Service Bulletin N° 86

SUBJ: **INDEPENDENCE DAY** Potential Balltrap in the Plastic Under-Trough

Fig. 2

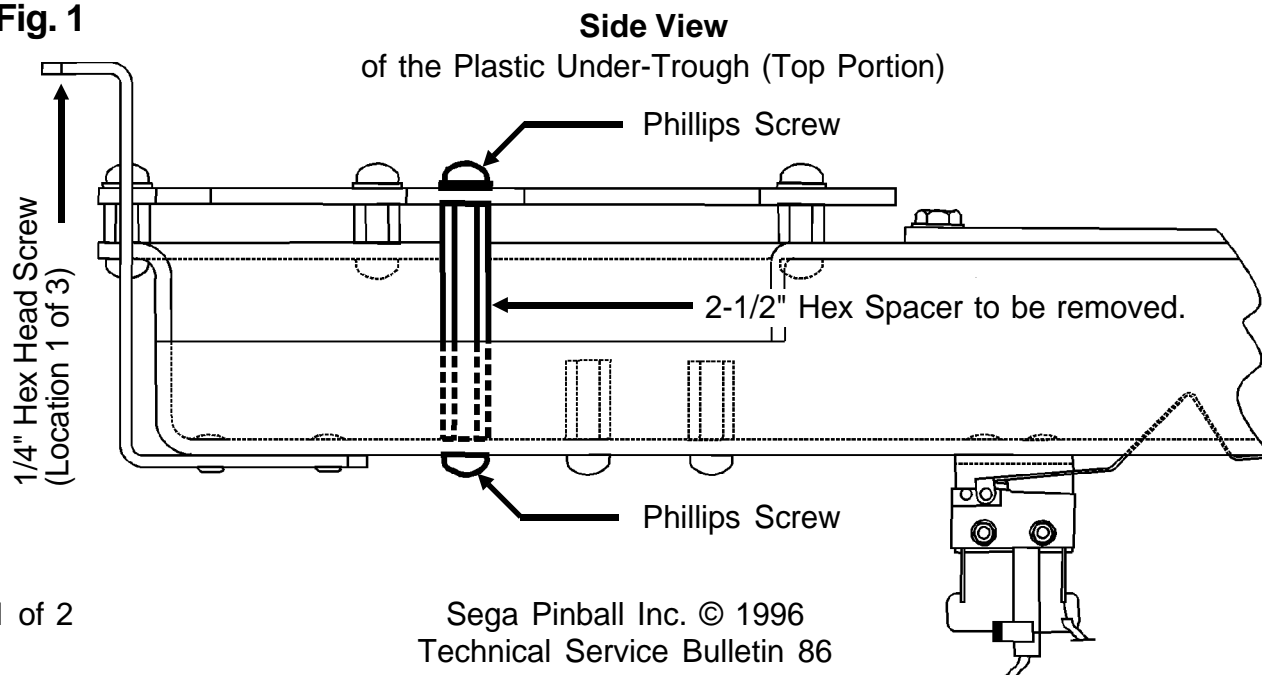
SYMPTOM: Balls get trapped in the Plastic Under-Trough Ramp beneath the *Alien Head*.

CAUSE: We have found a **potential** for a balltrap between the 2-1/2" Hex Spacer and the back wall of the Under-Trough because of normal variations in vacuum-formed plastic ramps (see Fig. 1 below).

SOLUTION: Remove the Plastic Under-Trough Ramp Assembly by removing the three 1/4" Hex Head Mounting Screws. Remove the two Phillips Screws and the 2-1/2" Hex Spacer (see Fig. 2 on the next page). Reattach the Under-Trough.

NOTE: This spacer was there strictly to give **additional** support to the clear plastic cover over the top of the trough. *Removing it will not create any problems.*
